Template for comments and convener's observations

Date:2019-03-21

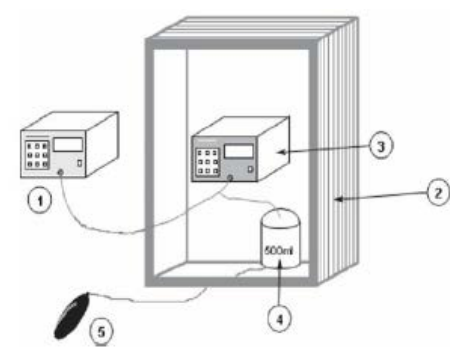
Country Code ¹	Part	Clause/ Subclause	Paragraph/ Figure/Table	Type of comment ²	Comments	Proposed change	Convener's responses
						<p>only be applied to the parts of the sample which are accessible to the operator during normal use of the instrument. The time interval between successive discharges must be at least 10 s.</p> <p>14.3 Results The standard deviation due to the electrostatic discharges (s_{L5}) is calculated according to subclause 3.3 with subscript j representing each combination of electrostatic discharge.</p>	
0085 BR	2	15 (New)		Te	Once the suggestion on clause 5 of Rxxx-1 is accepted, this clause needs to be added.	<p>15 Determination of standard deviation due to the radiated, radio-frequency, electromagnetic fields</p> <p>15.1 Apparatus</p> <ul style="list-style-type: none"> • T-piece connectors and hoses; • Rigid vessel with a capacity of 500 ml \pm25 ml; • Calibrated reference manometer which complies subclause 5.3 of Rxxx-1; • Pressure generator, e.g. ball pump (hand pump) with a deflation valve; • Equipment to generate radio-frequency, electromagnetic fields according to the latest version of IEC 61000-4-3. <p>15.2 Procedure Connect, as shown in the figure 3, the non-automated sphygmomanometer with the rigid vessel and the reference manometer. Perform steps described in 2.2 (without wait 5 min) at 20 °C \pm5 °C and ambient humidity. Set pressure to value between 0 kPa and 37 kPa or the maximum pressure of the scale range (whichever is less).</p>	Disagree The suggestion on clause 5 of Rxxx-1 is not accepted.
